**CERTIFICATE OF APPROPRIATENESS**

**Property:** 828 W Cottage Street, Lot 3, Block 221, East Norhill Subdivision. The property includes a historic 1,128 square foot, one-story wood frame single-family residence and a detached garage situated on a 5,512 square foot interior lot.

**Proposal:** Alteration – Replace non-original front porch columns with tapered wood columns on brick pedestals and install brick wing walls alongside the front steps  
See enclosed application materials and detailed project description on p. 5-8 for further details.

**PROPOSED PORCH ELEVATIONS**

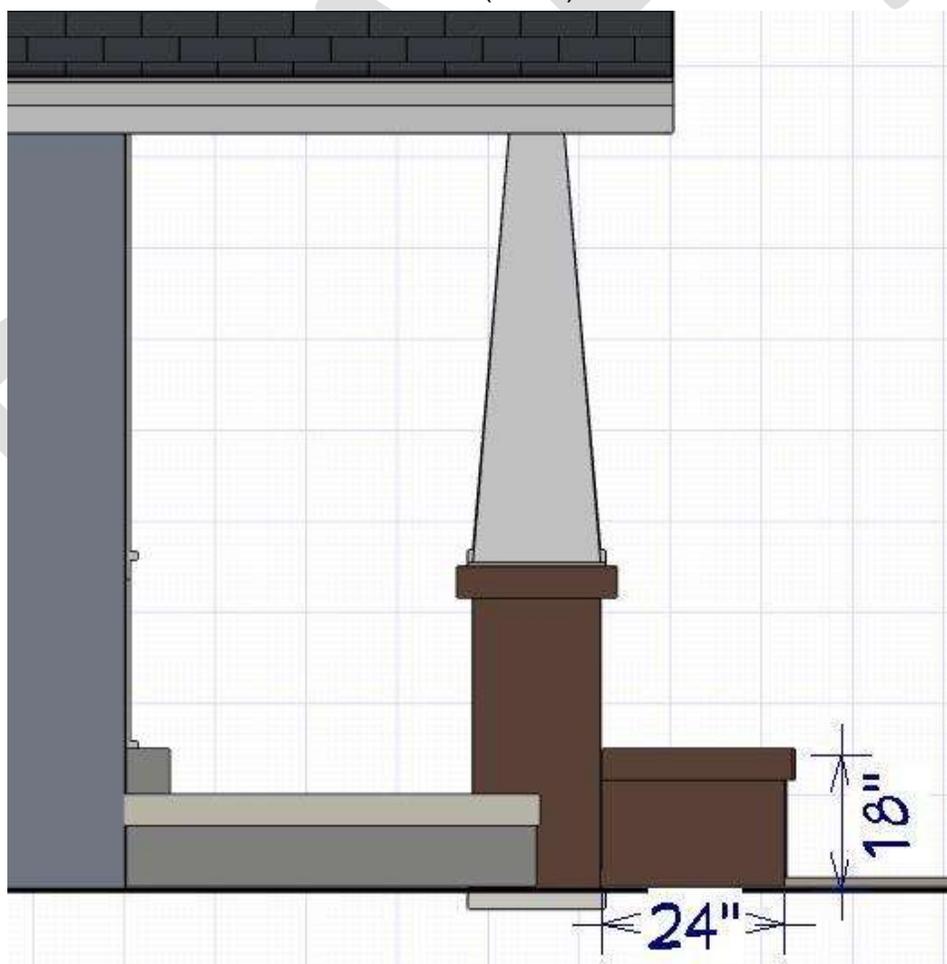
**Porch:** The residence features a non-original concrete front porch with four non-original round columns. The columns will be removed and replaced with tapered wood columns measuring 8" wide at the top and 12" wide at the base on 18" wide brick pedestals measuring 3'-10" in height. 18" tall brick wing walls will be installed along the existing porch steps.
